HISTORIC AND DESIGN REVIEW COMMISSION

July 01, 2015

HDRC CASE NO: 2015-269
COMMON NAME: 7622 S Presa
LEGAL DESCRIPTION: NCB 10930 BLK LOT 20 (MNFA DEVELOPMENT SUBD) 2013-NEW ACCT PER SPLIT PER PLAT 9642/4-6 FILED 6/8/2012
ZONING: C2 RIO-6
CITY COUNCIL DIST.: 3
APPLICANT: Jenifer Paz
OWNER: Money Cay, LLC
TYPE OF WORK: New construction of a gas station
REQUEST:

The applicant is requesting a Certificate of Appropriateness for approval to construct a Stripes convenience store at the corner of S Presa and SE Military with eight fuel dispensers. The convenience store will be constructed on a lot that is currently vacant and will feature materials consisting of stucco, nichiha panels and a glass curtain wall system.

SHEET: C1.0

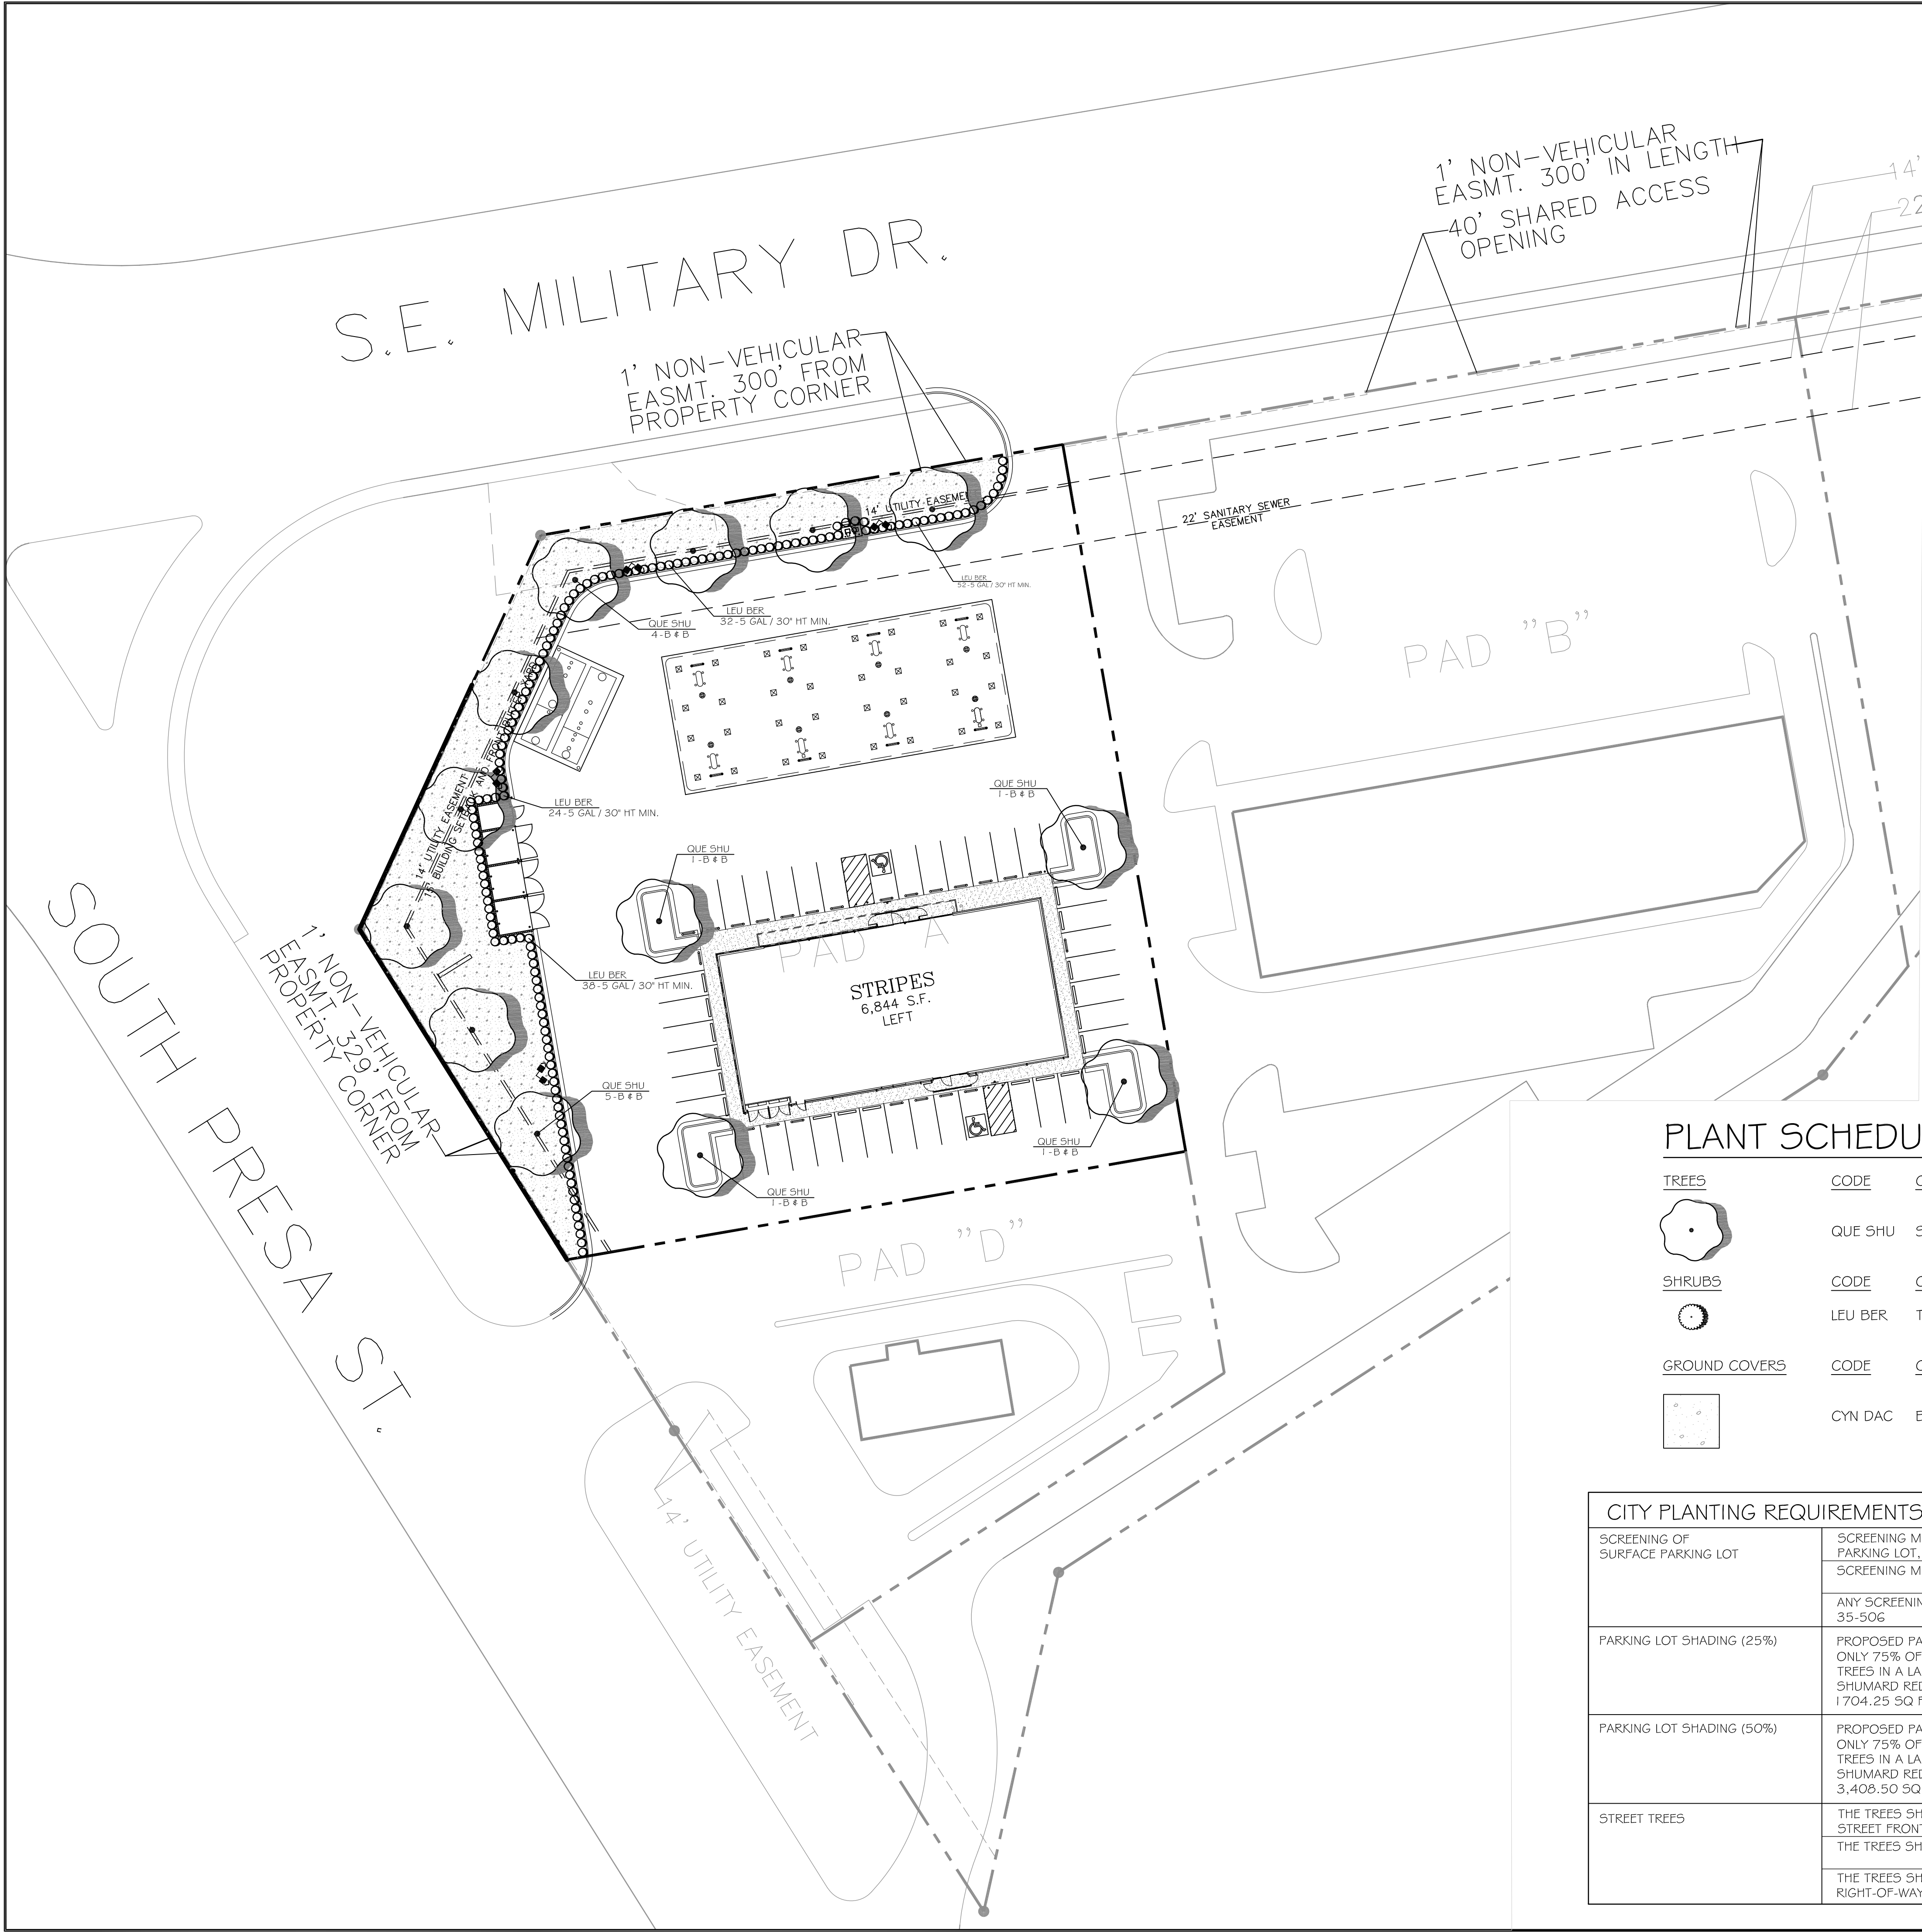
- e. Regarding building orientation and entrances, buildings should be oriented on a site taking into consideration the context of the block. In addition to this, primary entrances should be distinguishable from secondary entrances and should feature a change in material or color, a change in scale of openings or another architectural element. This applicant has provided information regarding each of these requirements and is consistent with the UDC Section 35-673(b).

- f. At the public right of way along both SE Military and S Presa, the applicant has proposed to plant trees. This is consistent with and required by the UDC Section 35-673(f)(3).

- i. That the applicant provide staff with information regarding site lighting.
- ii. That the applicant provide staff with information regarding the installation of curbs and gutters along the street edge at the time of parcel improvement.
- iii. That the applicant reduce the height of the proposed monument sign to no more than six feet in height and eliminate any proposed digital signage.

STREET ELEVATION

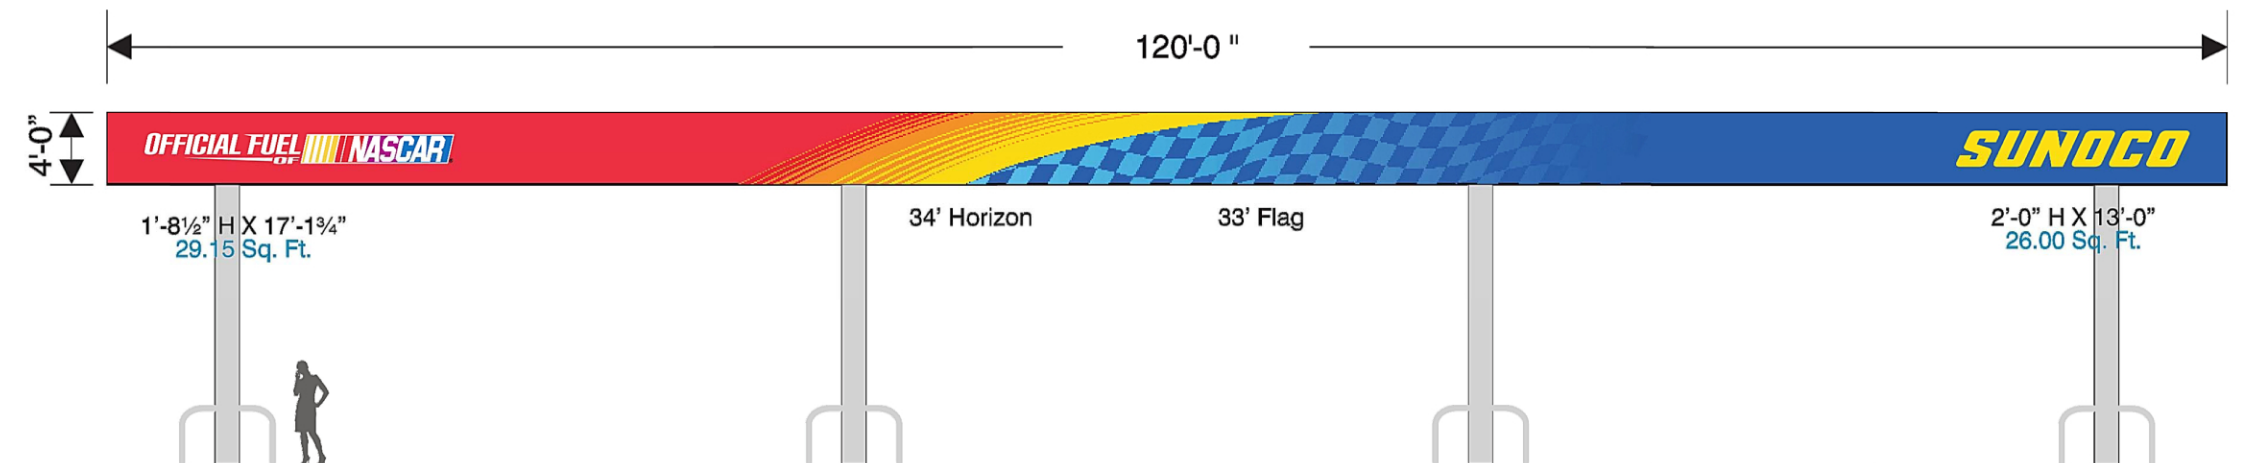
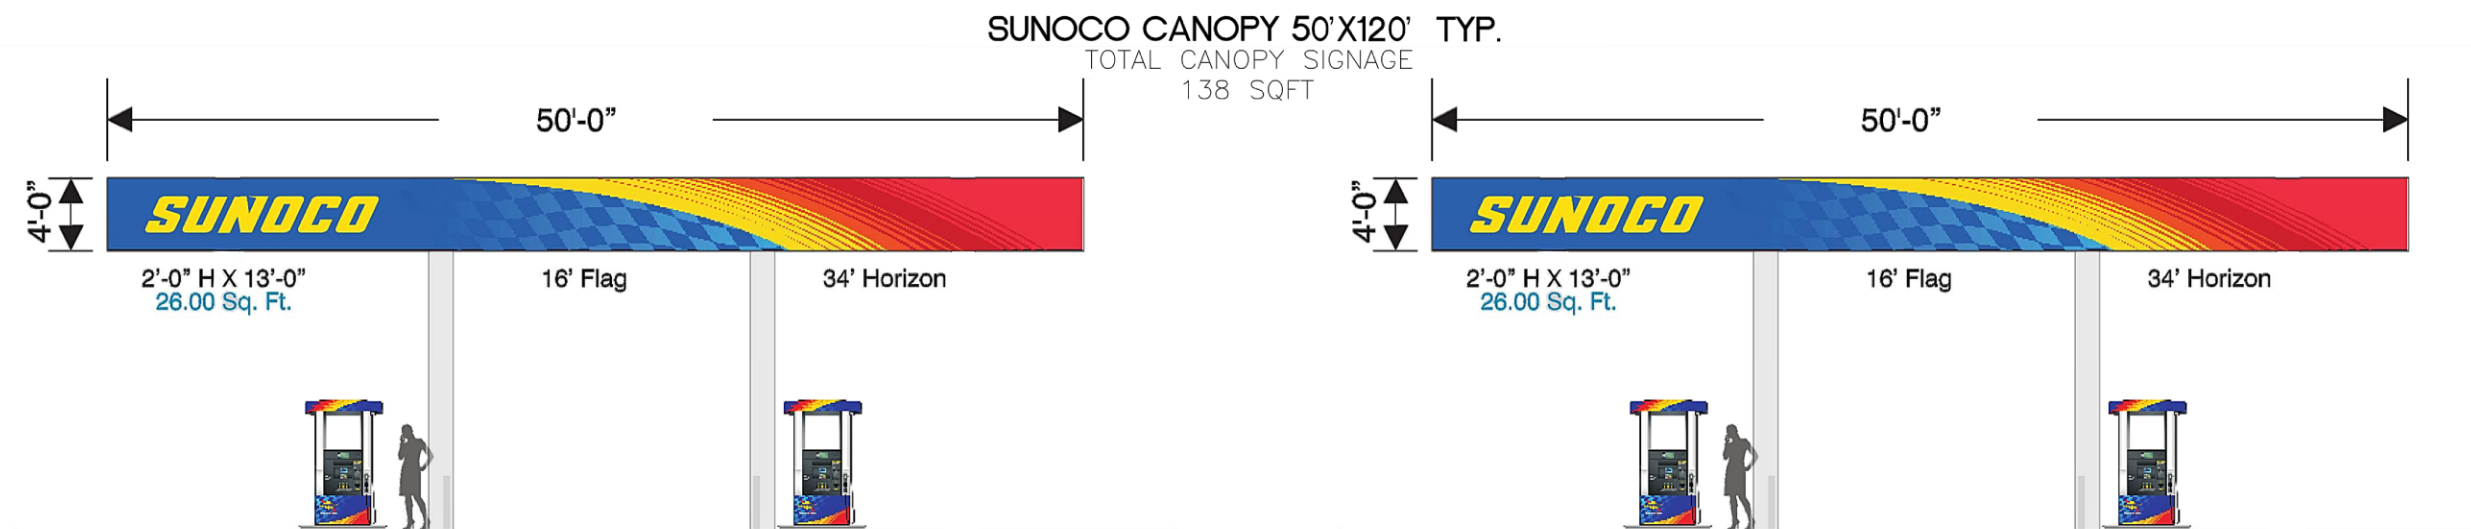
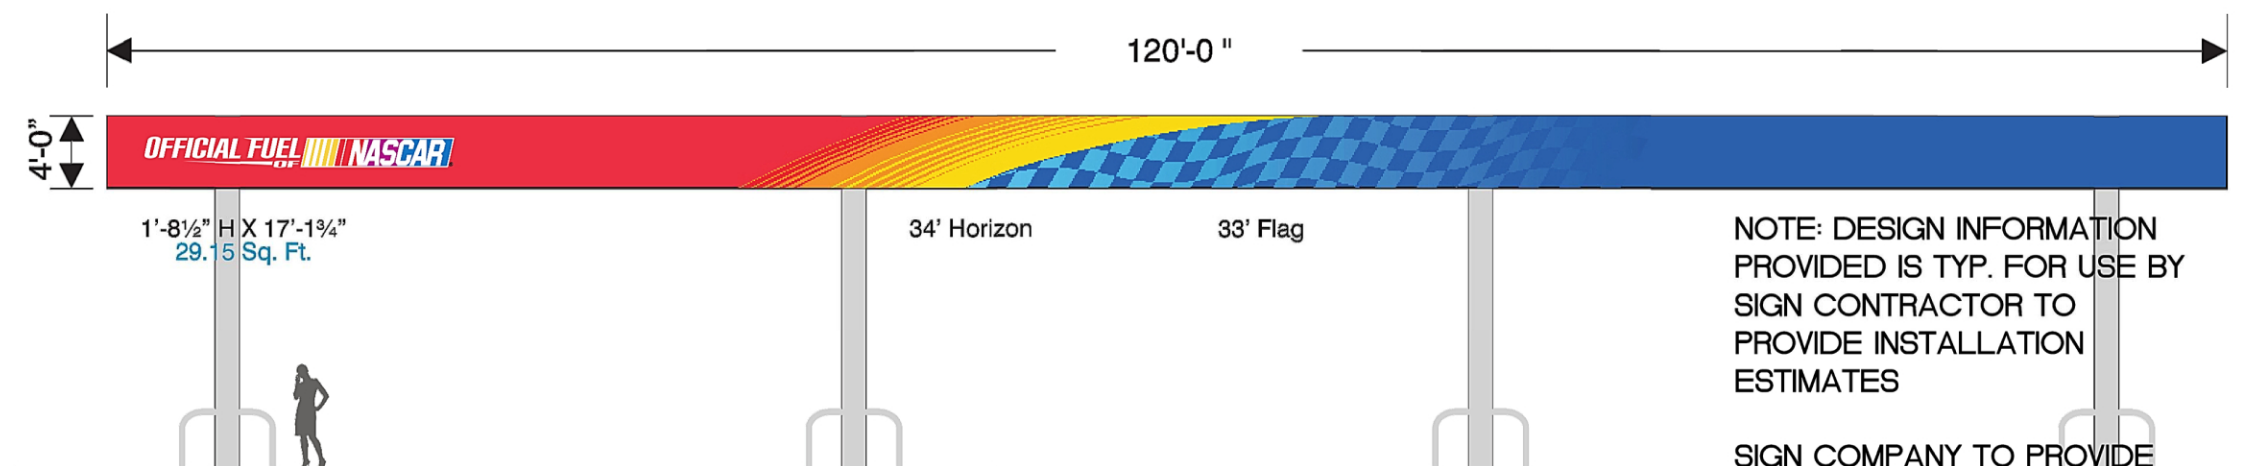
- k. Facades in RIO districts should be separated into three distinct segments featuring a base, mid section and cap. The applicant has achieved this through a change in materials, color and building mass. This is consistent with the UDC Section 35-674(e).

- l. The applicant has proposed a canopy to shelter the proposed fuel dispensers to the north of the site. The canopy is to be clad with aluminum panels. This is consistent with the UDC Section 35-674(d).

- m. According to the UDC Section 35-678 regarding signs and billboards in RIO districts, requests for signage are not to exceed more than fifty square feet and should not include more than three total signs. Given the nature and purpose of this business, staff finds that the proposed signage is appropriate, however, the applicant is to remove the proposed digital signage to become consistent with Section 35-678(k)(9) and that the proposed monument sign is to be no taller than six feet in height.
